Re: Aberdeen Water Tower and Transmission Line
Aberdeen, South Dakota
SRF # C462072-04
EDA# 05-79-06091
Helms # 8542

ADDENDUM NUMBER 1

The following modifications are made to the plans and specifications for the Aberdeen Water Tower and Transmission Line Project.

TRAFFIC CONTROL PLAN SHEETS # 46-53

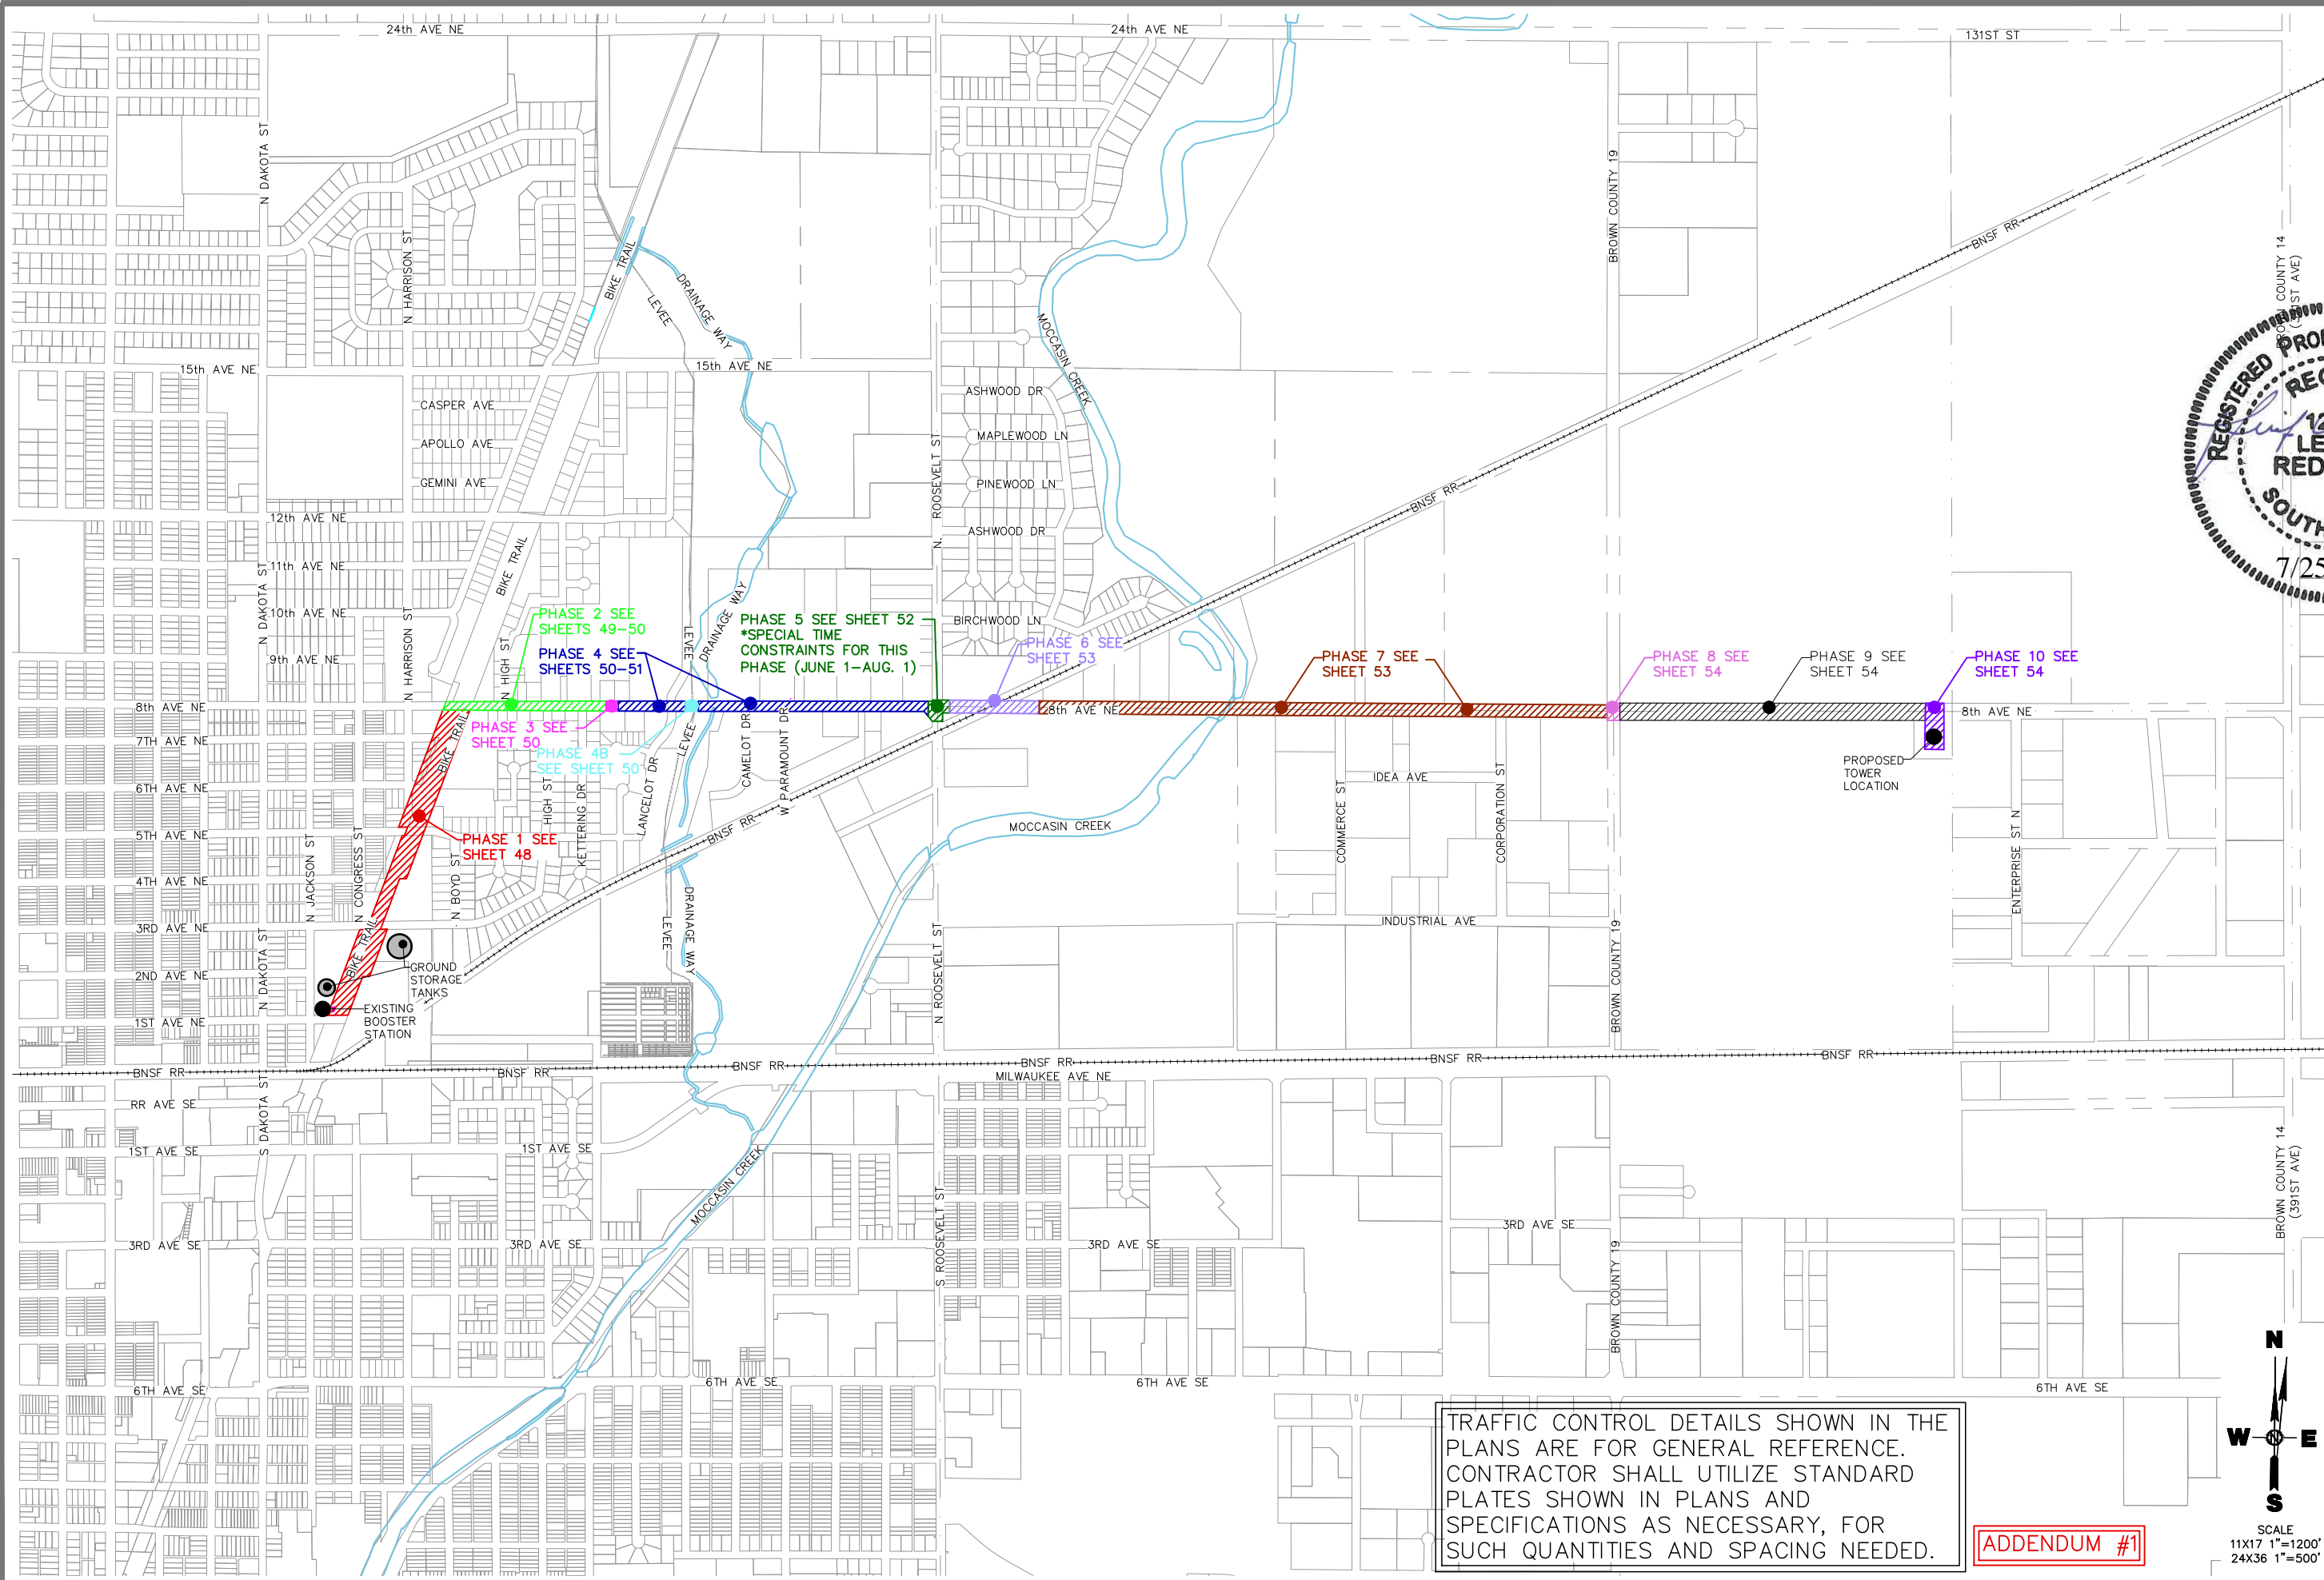
SHEET 46-53: TRAFFIC CONTROL: Remove and Replace traffic control sheets with attached.
